Access Compliance Report
Public Rights-of-Way
(Curb Ramps)

Main Street: ETON_PL | **Cross Street: TRIAD_LN** | **Location: SE**

ADA ID: RPRK211028121242 | **Ramp Type: Type 4 - Parallel** | **Initial Pass/Fail: Fail** | **Overall Compliance: No** | **Severity Score: 2**

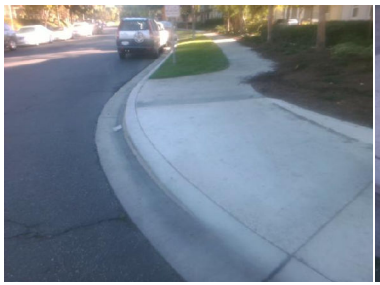
Compliance	Description	Data	Compliance	Description	Data
N/A	Ramp Length LT (in)	**137**	**N/A**	Ramp Length RT (in)	**128**
Yes	Ramp Width LT (in)	**90**	**Yes**	Ramp Width RT (in)	**89**
Yes	Ramp Run Slope LT (%)	**5.2**	**Yes**	Ramp Run Slope RT (%)	**1.6**
Yes	Ramp Cross Slope LT (%)	**1.1**	**No**	Ramp Cross Slope RT (%)	**2.6**
N/A	Landing Present	**N/A**	**N/A**	DWS Provided	**N/A**
N/A	Landing Length (in)	**N/A**	**N/A**	DWS Contrast	**N/A**
N/A	Landing Width (in)	**N/A**	**N/A**	DWS Length (in)	**N/A**
N/A	Landing Run Slope (%)	**N/A**	**N/A**	DWS Full Width	**N/A**
N/A	Landing Cross Slope (%)	**N/A**		DWS Offset Type	**N/A**
N/A	Landing Movement Obstructed?	**N/A**	**N/A**	DWS Offset Left (in)	**N/A**
	Landing Movement Type	**N/A**	**N/A**	DWS Offset Right (in)	**N/A**
N/A	Landing Shared	**N/A**			
N/A	Clear Space	**Yes**			
N/A	Clear Space To Crosswalk (in)	**N/A**			
N/A	Marked Crosswalk 1	**No**	**N/A**	Marked Crosswalk 2	**No**

Remove & Replace Curb Ramp With Two New Directional Ramps or Equivalent.

R304.5.3, STD 1115
